## Staff Report to the Zoning Administrator

Application Number: **181576**

**Project Description:** Proposal to combine two parcels, demolish the existing improvements, and construct a new 13,111 square foot retail pharmacy with a mezzanine for storage, a drive-through pharmacy window, an over-height fence/retaining wall, and related improvements, including frontage improvements and business signs.

CVS Pharmacy Santa Cruz  
 Figure 1  
**Study Intersections and Project Trip Distribution**

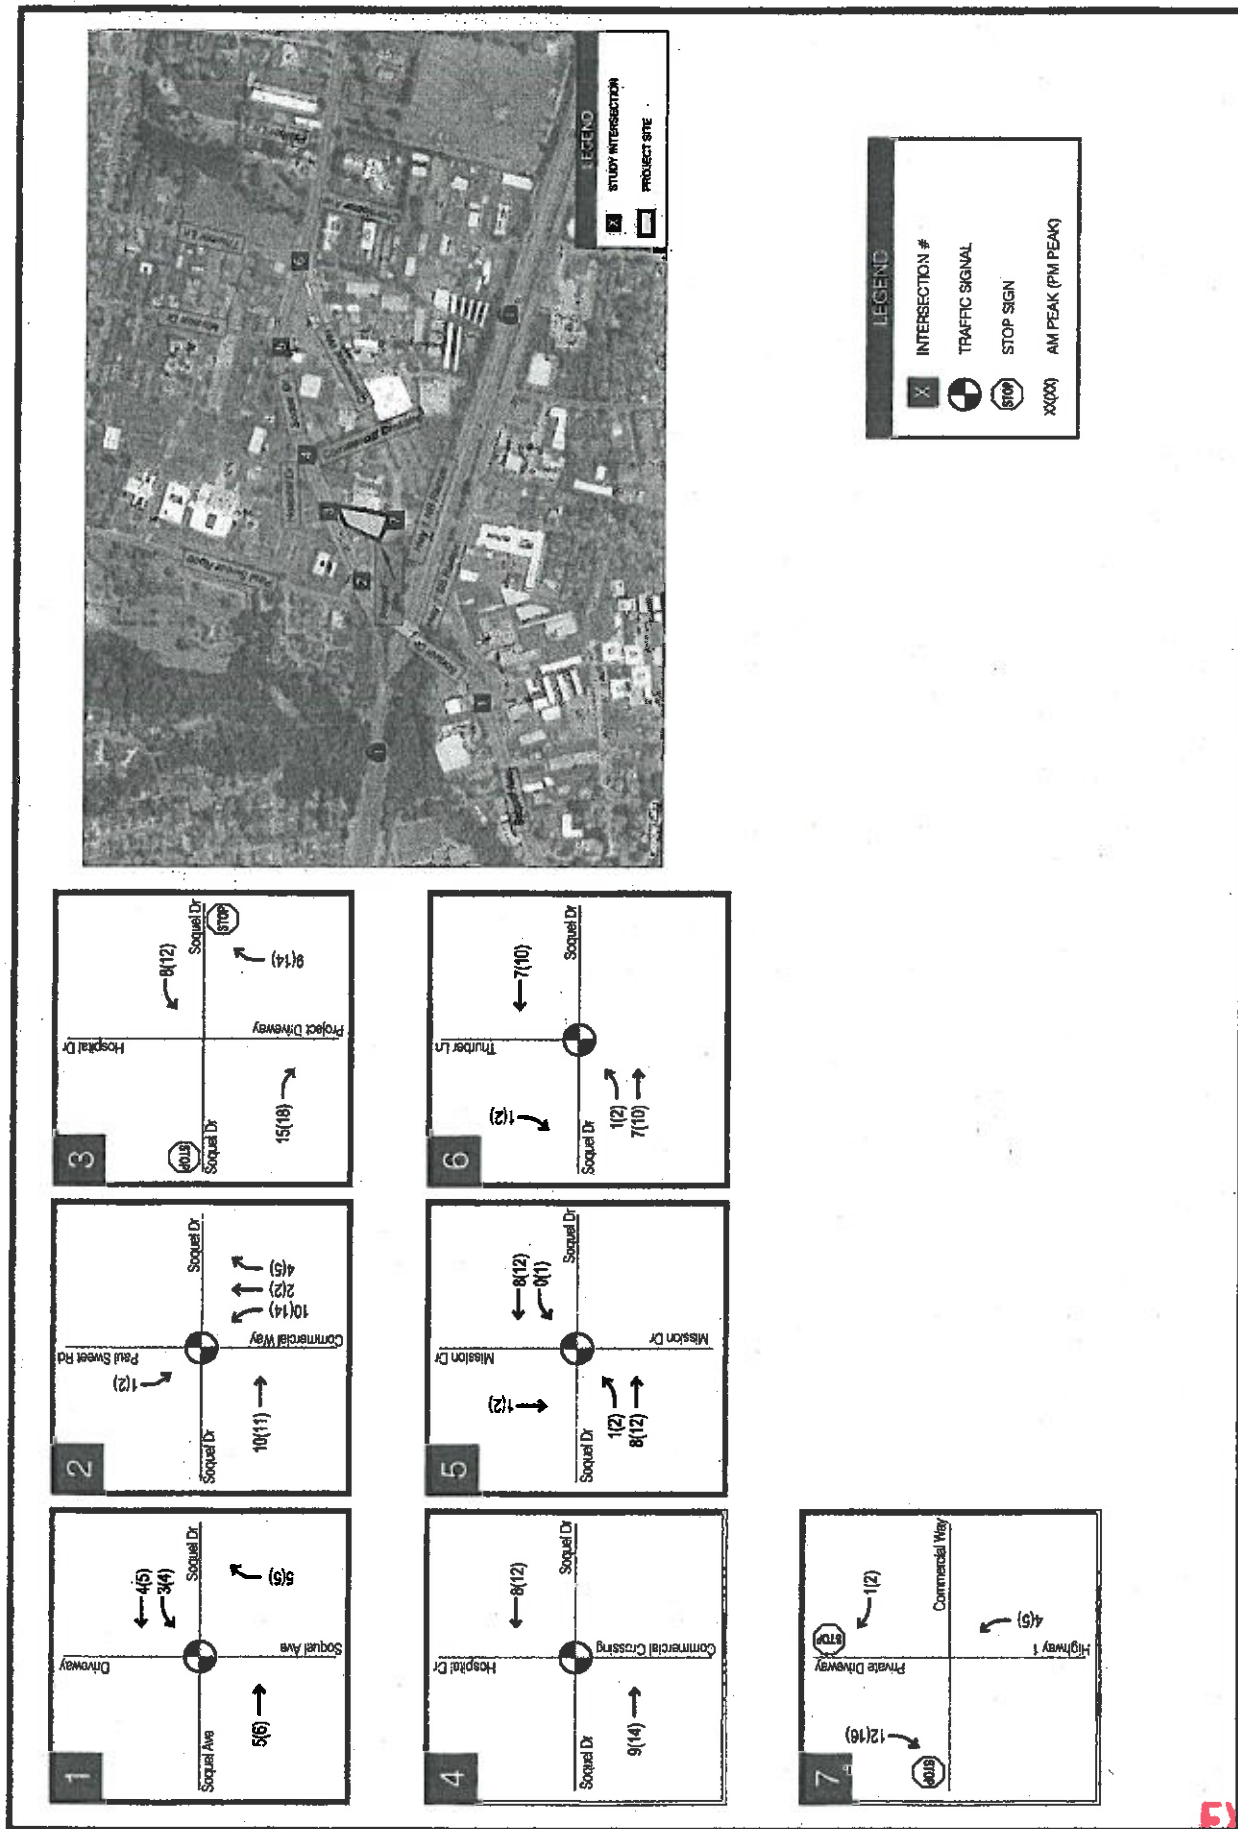
Comment 2: According to Figure 1 of the traffic study, approximately 24% of trips generated by this project will traverse the Highway 1 southbound on/off ramps at Soquel Avenue, but this intersection is not analyzed in the study. What's the rationale for leaving out analysis of this key intersection?

Response: Figure 6 (Intersection 1, northbound right and westbound left movements) shows that roughly 8 net new AM trips and 9 net new PM trips are anticipated to travel towards through the signalized Soquel Ave & Highway 1 on/off ramps intersection. This small number of trips does not justify studying the additional intersection.
